Letter of Response

Project Title: Lion Petroleum Convenience Store

Response to Fire Plan Review

Response to Plan Review

7 FLOOR PLAN
SCALE: 1/8" = 1'-0"

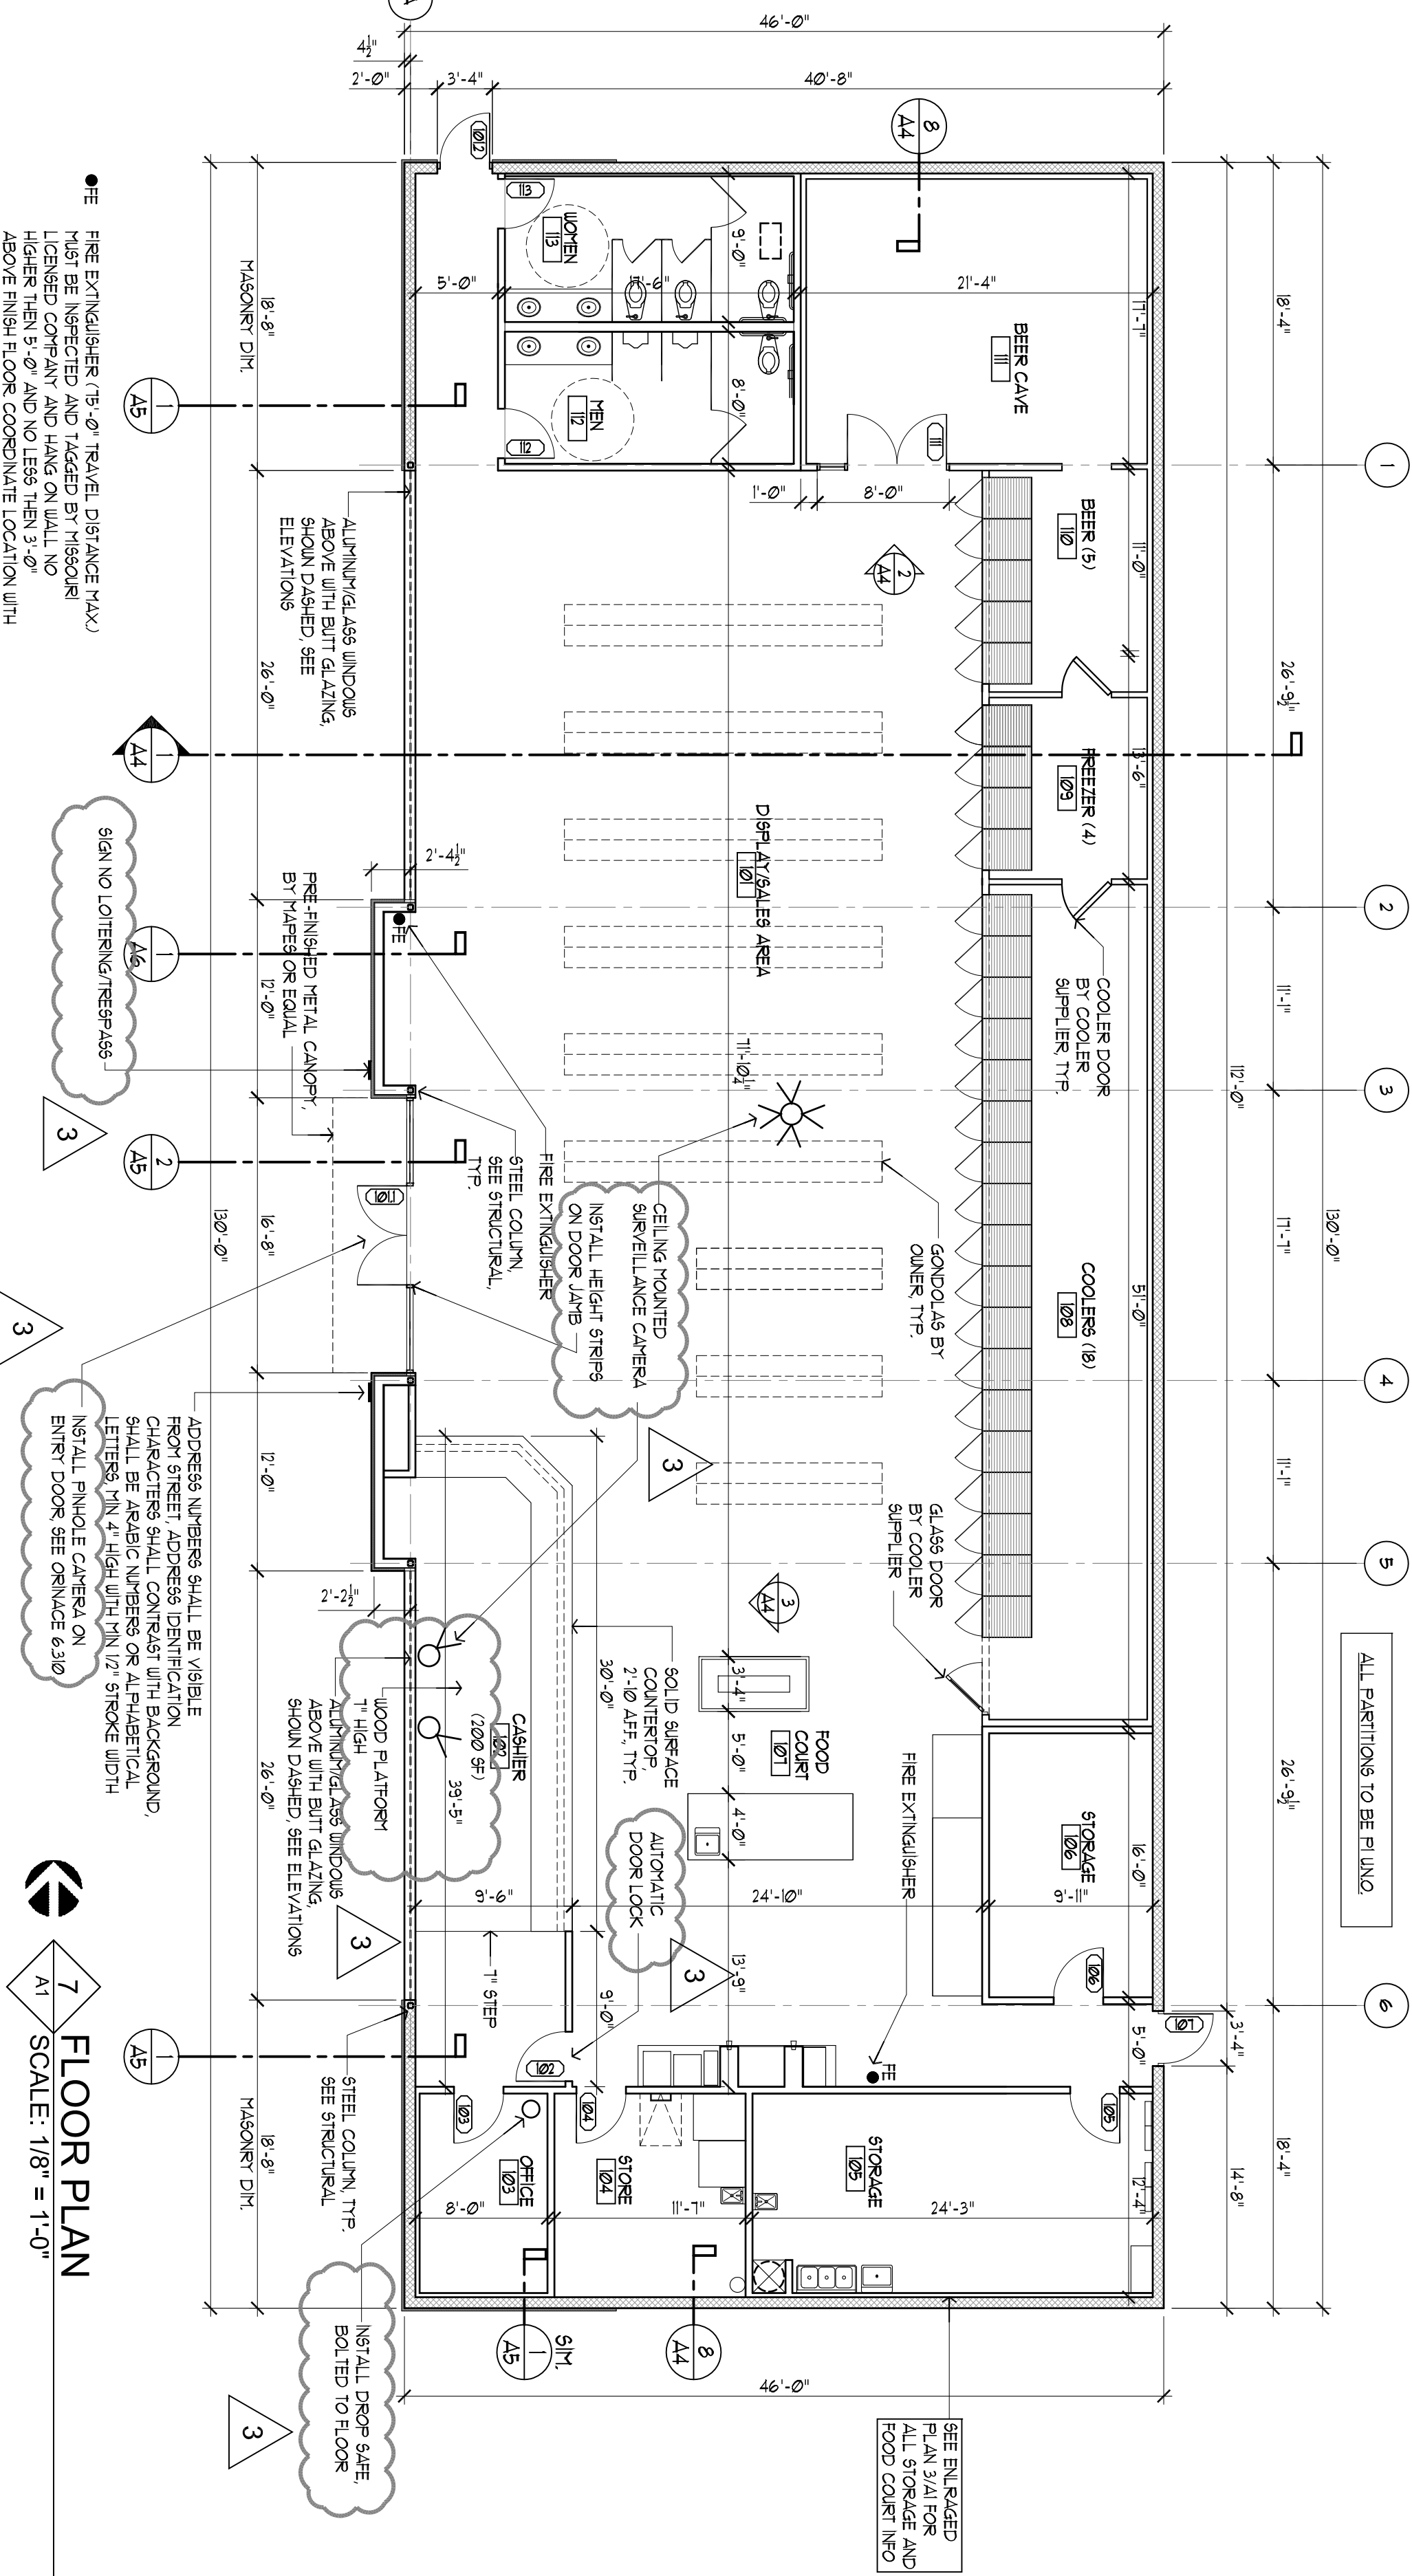
#4 Unified development ordinance – Section 6.310 requirements are shown in boxed and clouded area next to 7/A1 Floor plan, some items are shown on plan like surveillance cameras, pinhole camera, drop of safe, height strips and sign for no loitering , all items has been clouded

#13 platform height revised to 7", see 7/A1

H AND P EQUIPMENT

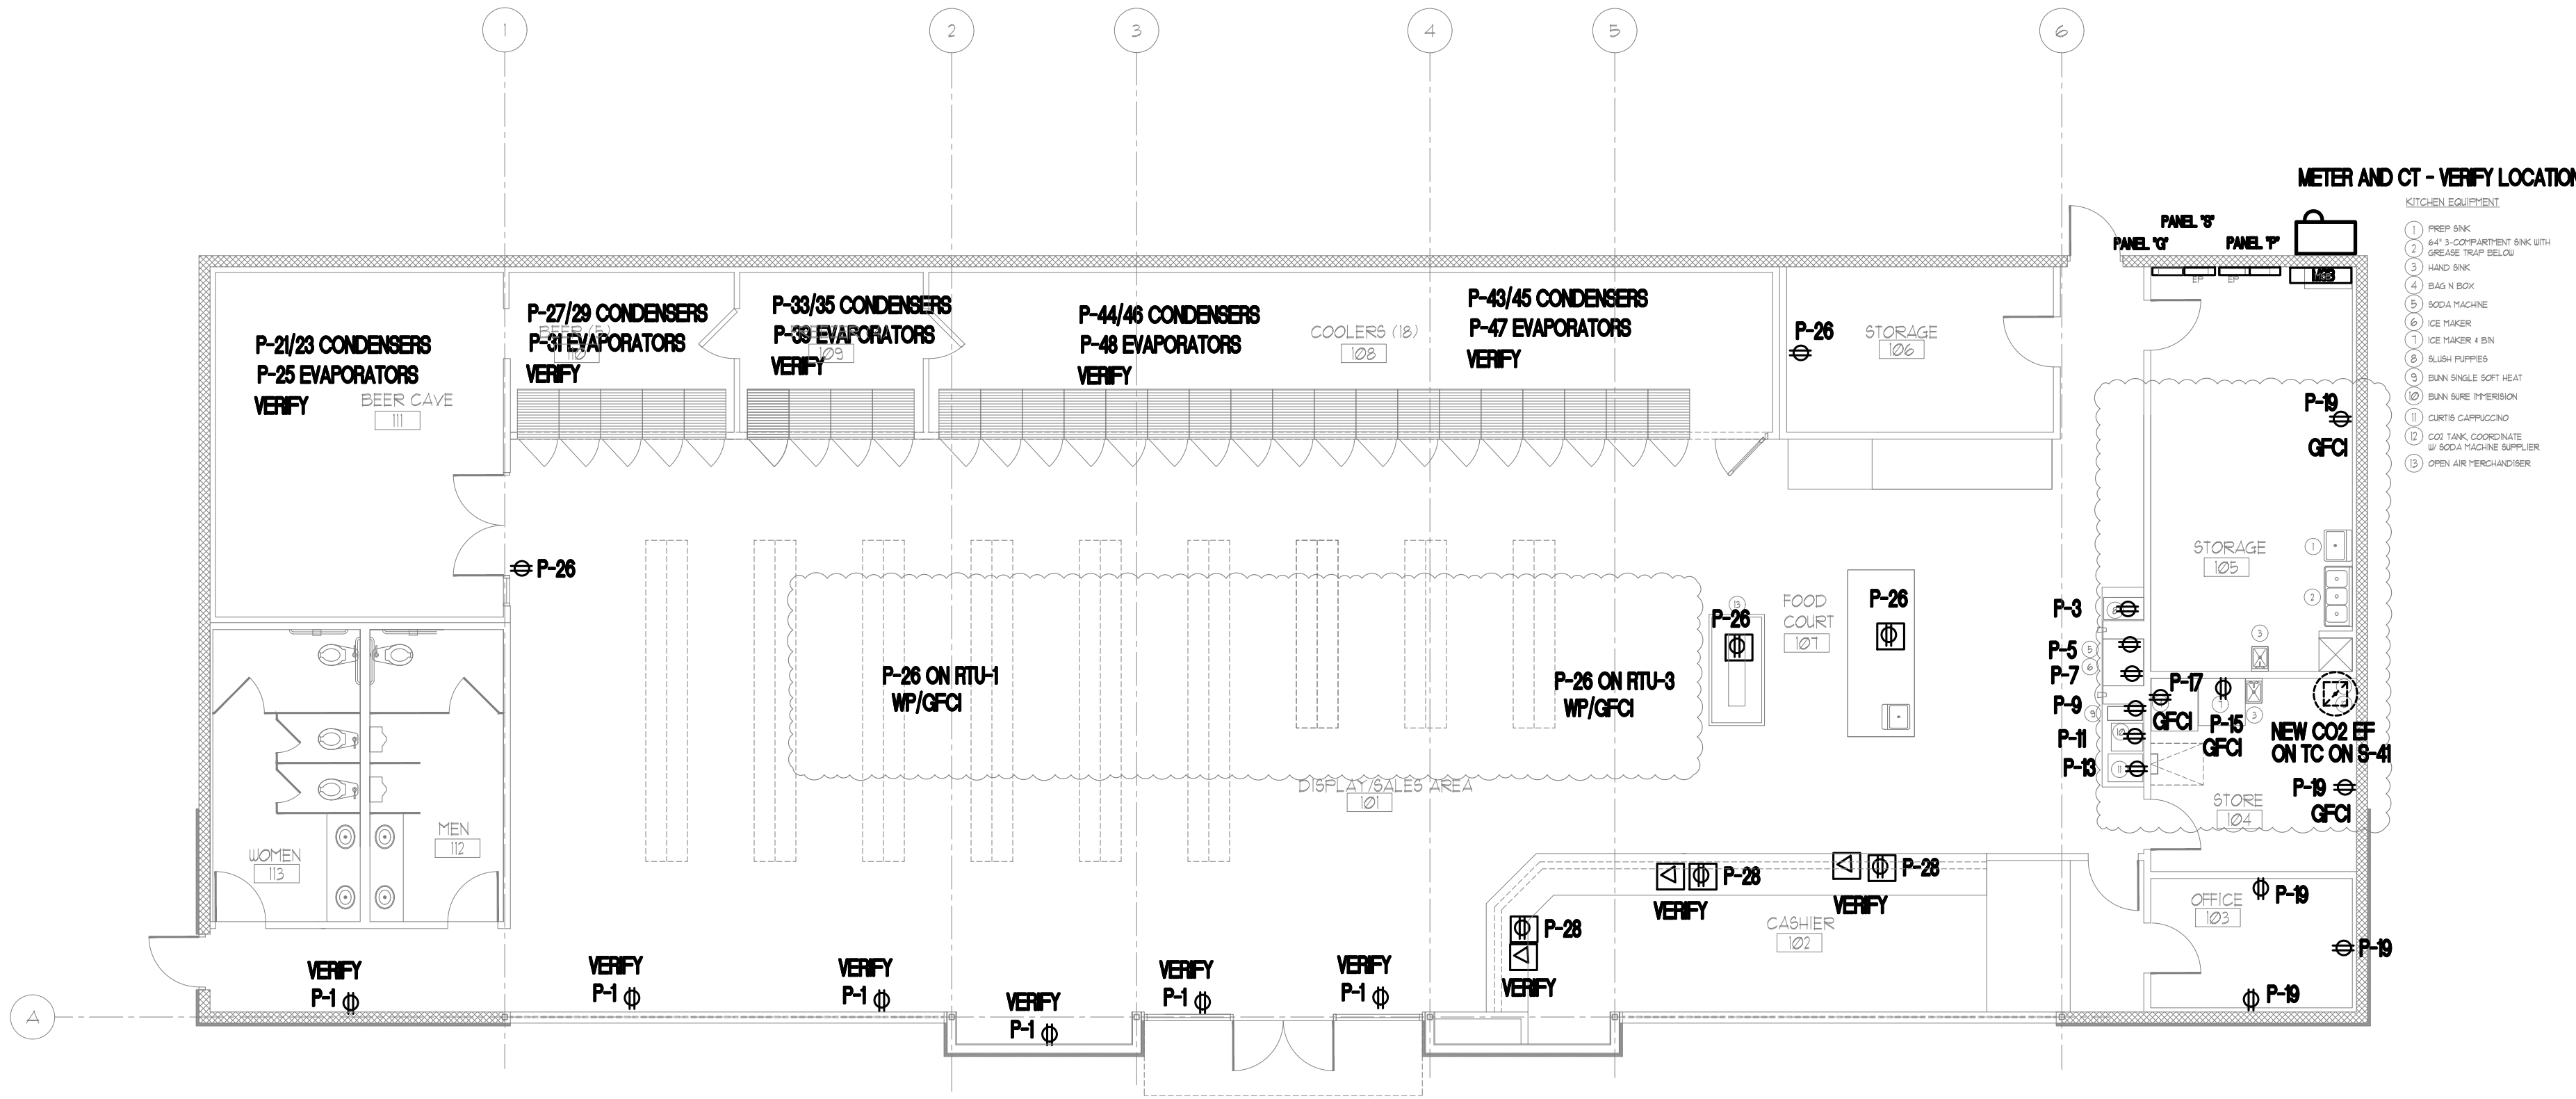
ITEM 12 FROM JOE FROSSE: TWO WP/GFCI ADDED TO RTU1 AND RTU2 ON SHEET E1

E-2

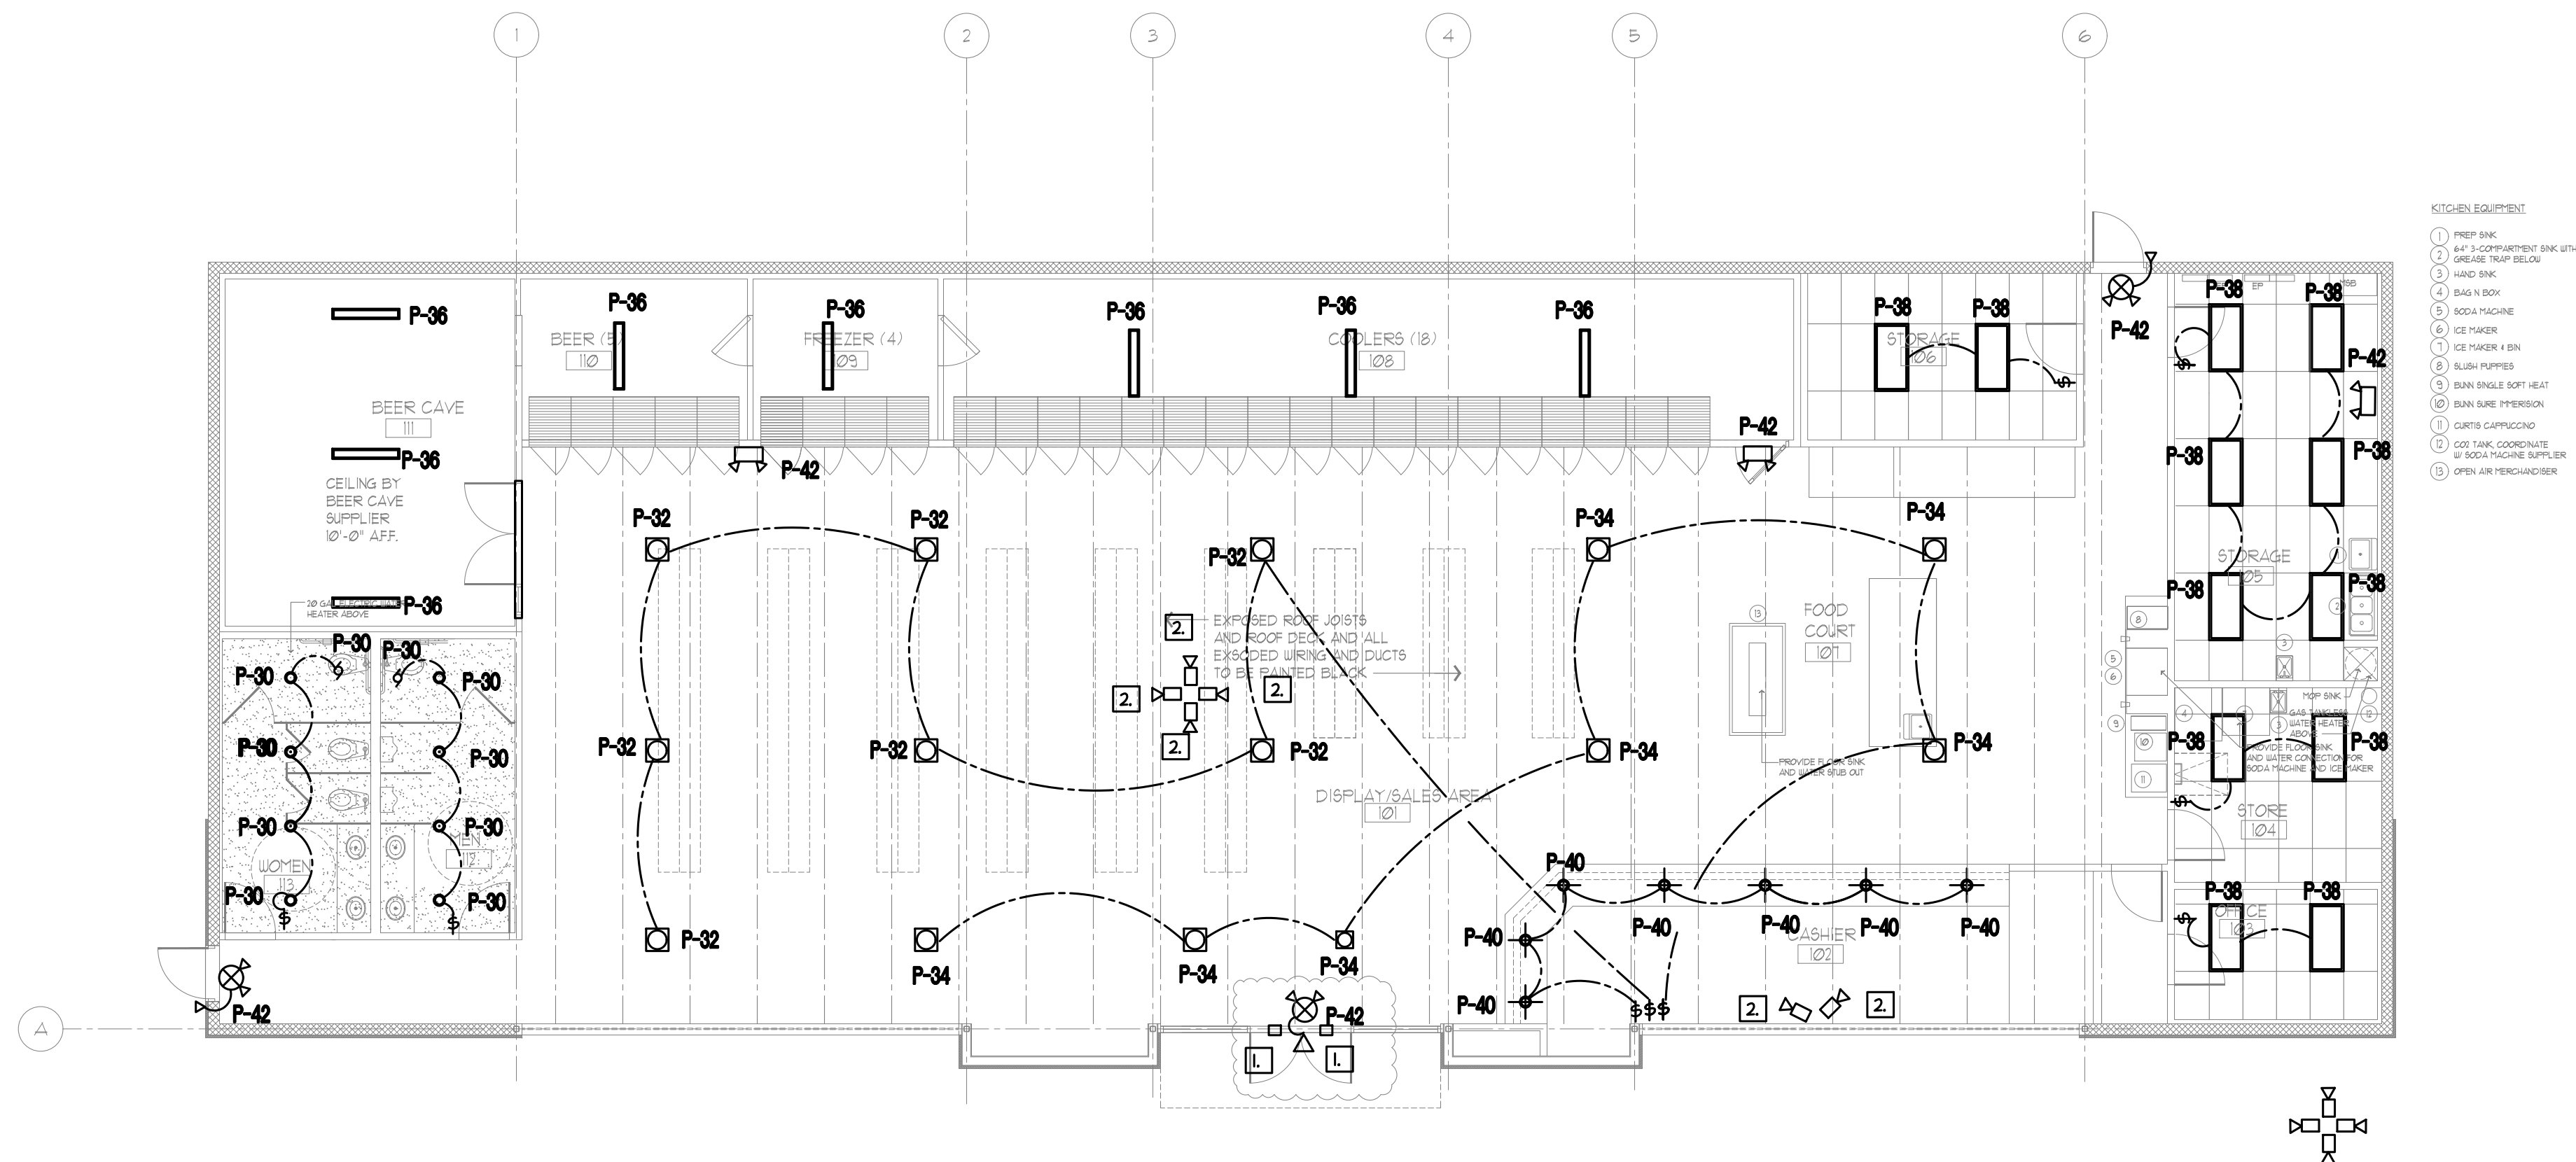
ITEM 10 FROM JOE FROSSE: EXIT AND EM LIGHTS ON LOCK ON CB AND ADDITIONAL HAVE BEEN ADDED TO ROOM WITH ELEC. PANEL SHEET E2

ITEM 3 FROM JIM EDEN: EXIT AND EM LIGHTS ON LOCK ON CB AND ADDITIONAL HAVE BEEN ADDED TO ROOM WITH ELEC. PANEL SHEET E2
